PCI-SIG ENGINEERING CHANGE NOTICE

TITLE:	Extension Devices
DATE:	Updated 6 October 2014
AFFECTED DOCUMENT:	PCI Express Base Specification, Revision 3.0/3.1, Multi-Root I/O Virtualization and Sharing Specification, Revision 1.0. This ECN comprehends the following PCI Express Base Specification, Revision 3.0 ECNs: Separate Refclk Independent SSC (SRIS) Architecture, 8.0 GT/s Receiver Impedance, L1 PM Substates with CLKREQ
SPONSOR:	Intel, IDT

Provide specification for Physical Layer protocol aware Retimers for PCI Express 3.0/3.1.

Figure 4-a Supported Topologies

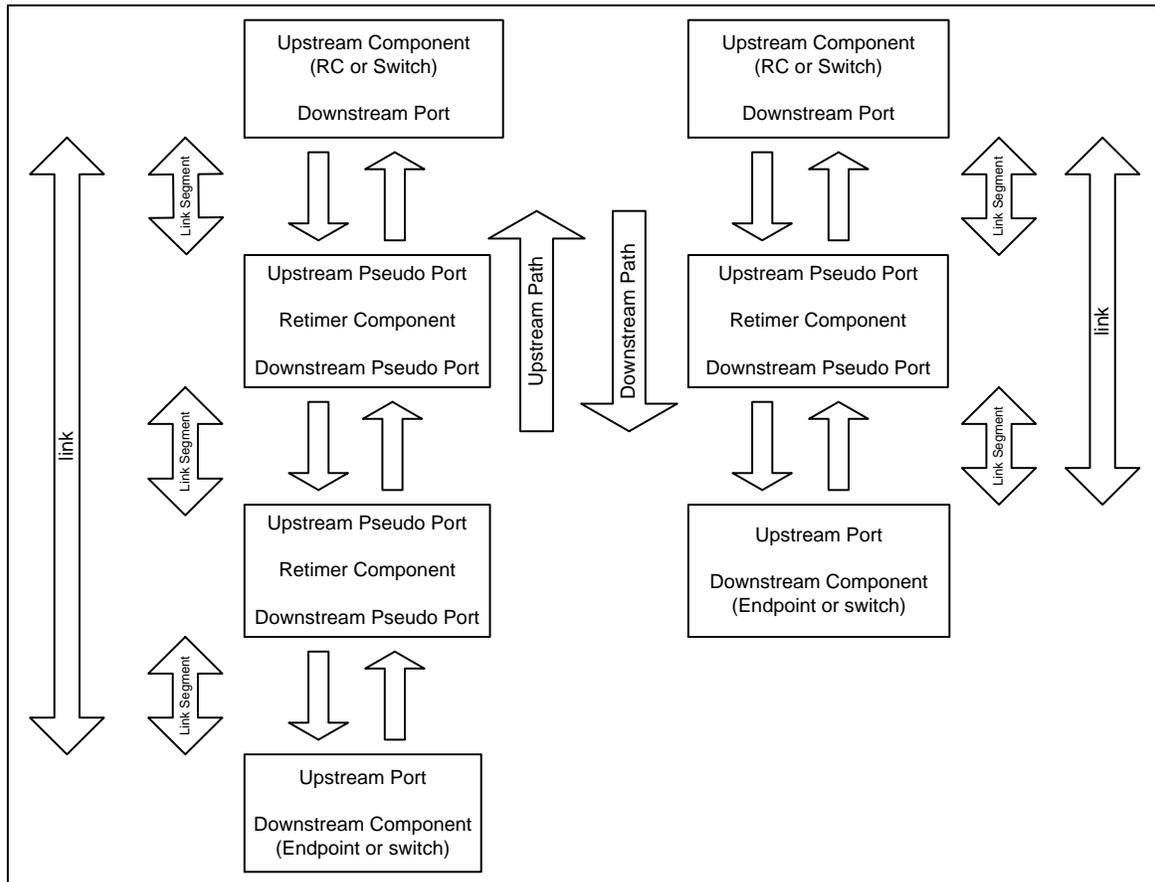
Figure 4-a Supported Topologies shows the topologies supported by Retimers defined in this specification. There may be one or two Retimers between the Upstream and Downstream Components on a Link. Each Retimer has two Pseudo Ports, which determine their Downstream/Upstream orientation dynamically. Each Retimer has an Upstream Path and a Downstream Path. Both Pseudo Ports must always operate at the same data rate, when in Forwarding mode. Thus each Path will also be at the same data rate. A Retimer is permitted

Figure 4-b Retimer CLKREQ# Connection Topology

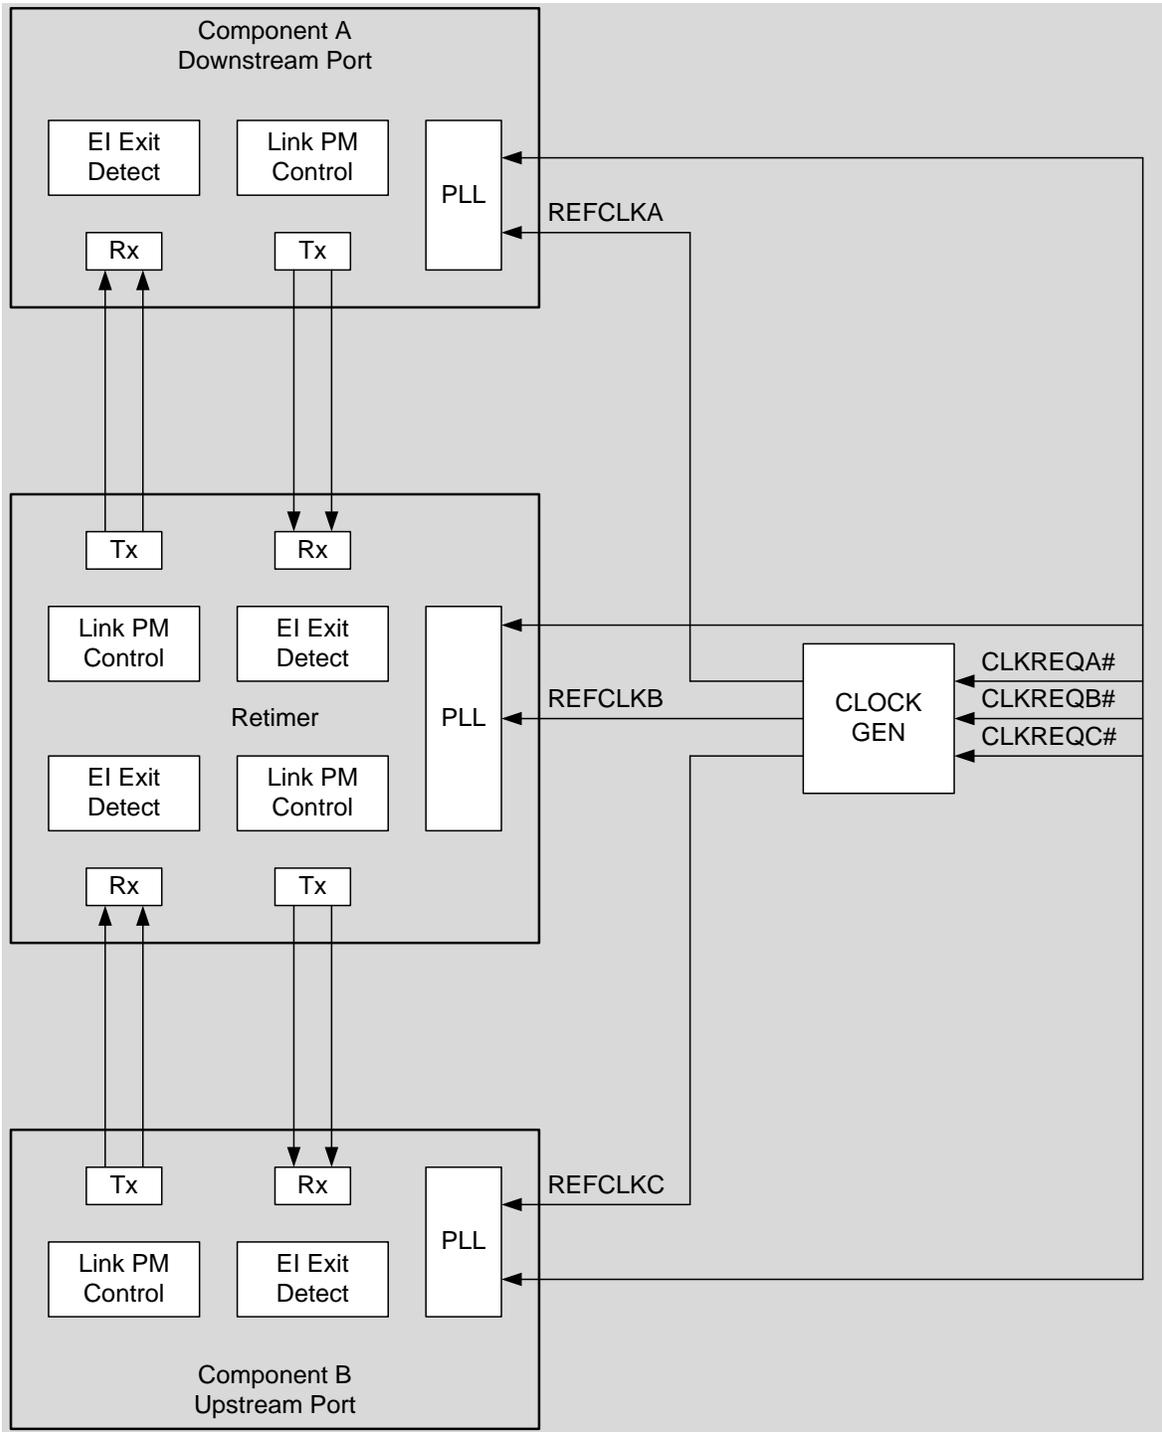
CLKREQ# Connection Topology with a Retimer Supporting L1 PM Substates

In this platform configuration the Upstream Component (A) has only a single CLKREQ# signal. The Upstream and Downstream Ports' CLKREQ# (A and C), and the Retimer's CLKREQB# signals are connected to each other. In this case, Upstream Component (A), must assert CLKREQ# signal whenever it requires a reference clock. Component A, Component B, and the Retimer have their REFCLKs removed/restored at the same time.

Figure 7-27: Link Capabilities 2 Register

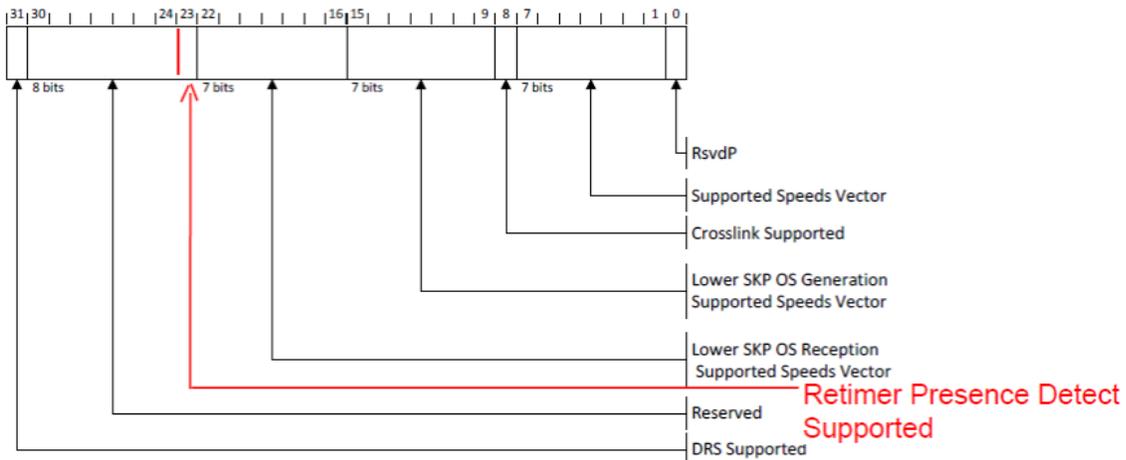
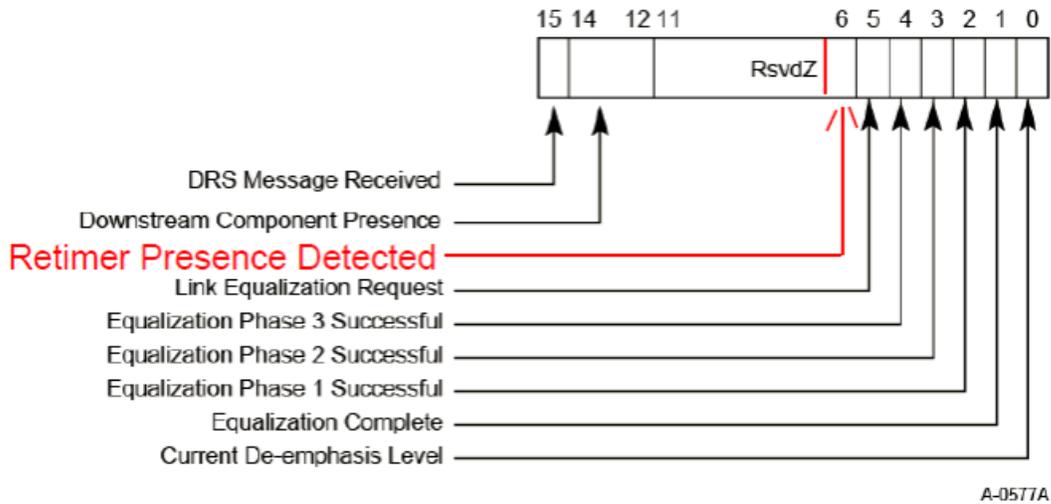
Modify Figure 7-27
